FREDERICK COUNTY PLANNING COMMISSION
September 11, 2019

TITLE: Urbana Town Center
The Goddard School

FILE NUMBER: SP13-09, 18908, APFO 18909, FRO 18910

REQUEST: Site Plan Approval

Exhibit 1 – Site Plan Rendering

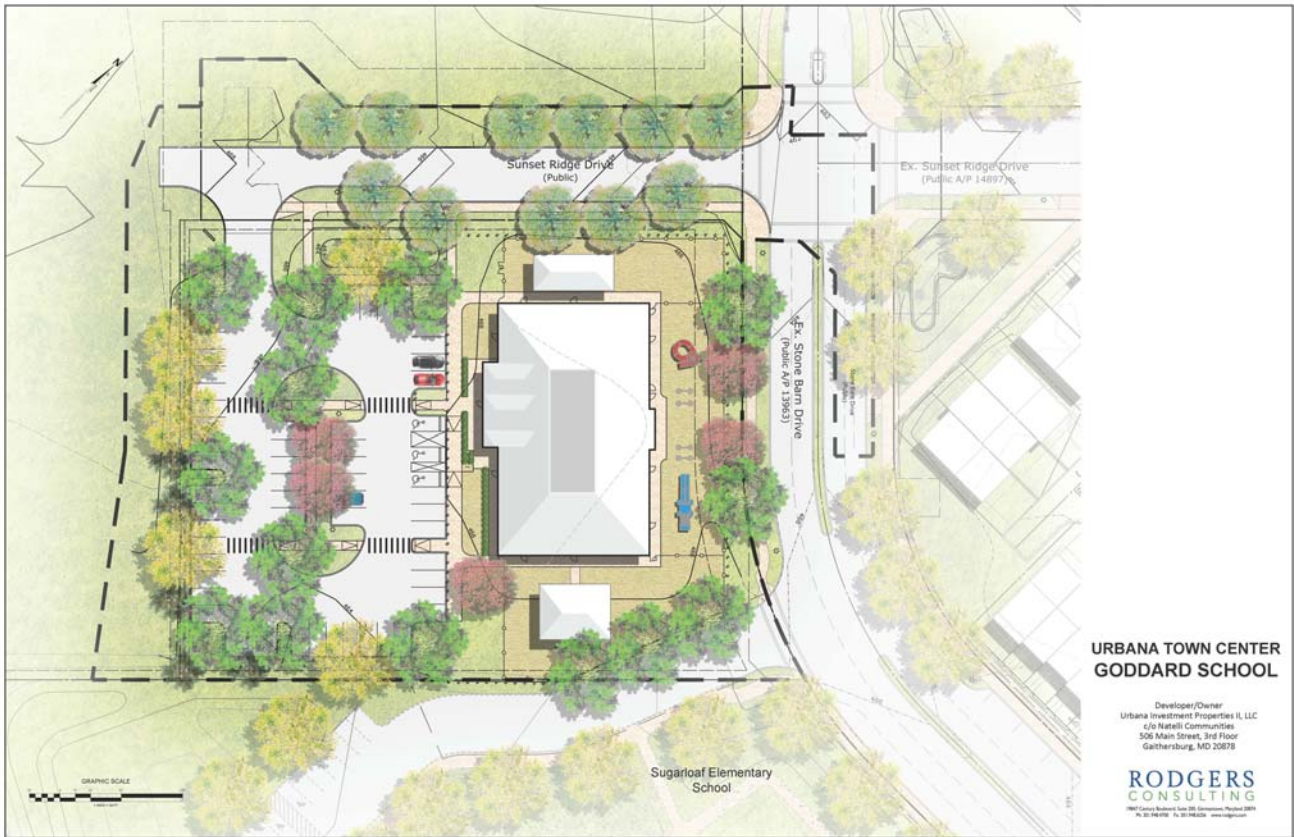
3. **Landscaping §1-19-6.400:** The landscape plan contains a variety of plant species, which provide screening and shade for the Child Care Center. The plan proposes a mix of evergreens, deciduous trees, and shrubs. Parking lot canopy coverage exceeds the 20% required.

The Applicant is requesting approval of a Street Tree Modification Request under §1-19-6.400(A) to provide an alternative landscape plan to meet the street tree requirements (see Exhibit #2). This alternate landscape plan proposes additional trees outside of the right-of-way, due to conflicts with intersection sight distance, lighting, and utilities.

1. **Access/Circulation:** One 24’ wide entrance is proposed on Sunset Ridge Drive. Loading and unloading is facilitated by a small loading space near the dumpster enclosure.
2. **Public Transit:** There is no local bus service for this Site.
3. **Parking:** Pursuant to Section 1-19-6.220 of the Zoning Ordinance for a Child Care Center, 1.5 parking spaces are required for each employee plus 1 space for every 10 children approved for care. The Child Care Center will have 24 employees and 162

students. This equates to 53 parking spaces required $((24 \times 1.5) + (162/10) = 36 + 17 = 53)$. The Site Plan proposes 55 parking spaces, which includes three (3) handicap spaces. The Applicant has submitted a Modification Request (Exhibit #2) seeking FCPC approval to allow for 2 additional proposed spaces. The justification letter notes that the Goddard School has requested as much parking as possible due to its logistical experiences at other facilities, particular the existing facility on Carriage Hill Drive.

4. **Pedestrian Circulation and Safety §1-19-6.220 (G):** Internal sidewalks are provided throughout the parking bays and surrounding the building. A sidewalk stub extends from the midpoint of the northwest property line to the sidewalk along Sunset Ridge Drive. The sidewalk system proposed effectively connects the Site to the greater sidewalk network within the Urbana Town Center community development.
5. **Bicycle Parking §1-19-6.220 (H):** Bicycle parking shall be provided as follows in accordance with the Zoning Ordinance:

1. Approval of a Parking Modification Request under §1-19-6.220(A)(2) to allow for 55 parking spaces, or 2 additional spaces than the required 53 spaces.
2. Approval of a Loading Space Modification Request under §1-19-6.210(D) to allow 1 shared small loading space/parking space, or 1 fewer space than the required 2 small loading spaces.
3. Approval of a Street Tree Modification Request under §1-19-6.400(A) to provide an alternative landscape plan to meet the street tree requirements.

1. Address all agency comments as the plan proceeds through to completion.
2. Lot must be recorded prior to applying for building permits.
